PLAN AND PROFILE OF PROPOSED STATE HIGHWAY

PRINCE WILLIAM PARKWAY INTERCHANGE AT REALIGNED BALLS FORD ROAD

VDOT Proj.No.6234-076-266

Notice of Design Change (NDC) #02
JUNE 2021

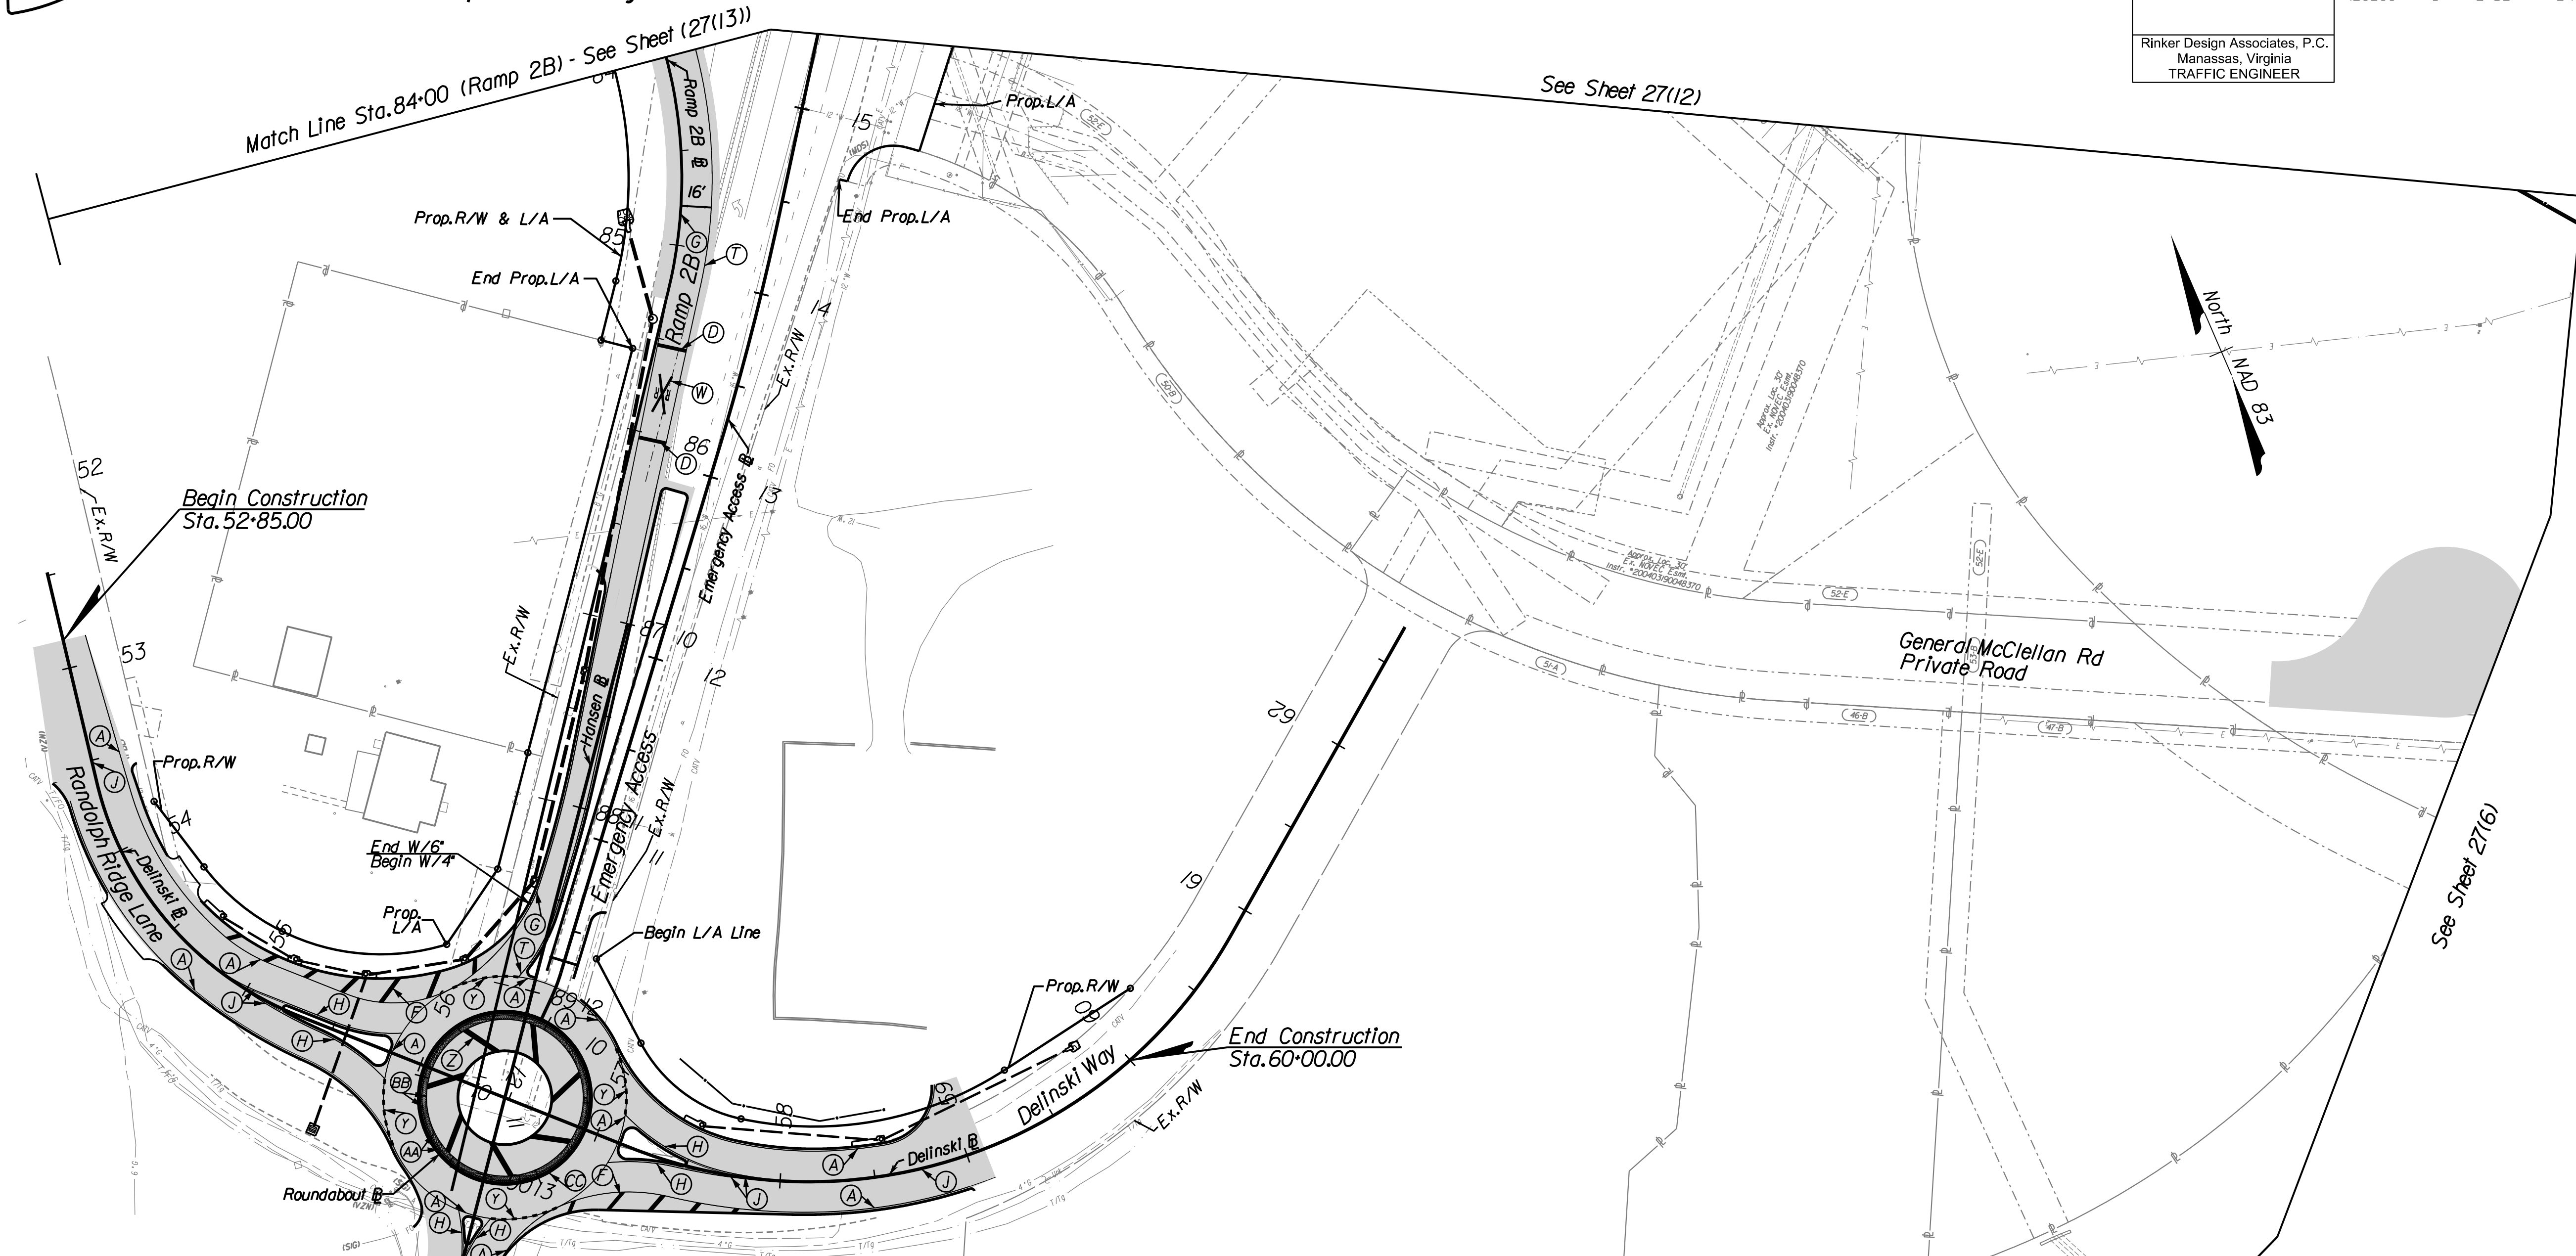
02 Revised sheet to include roundabout pavement marking.
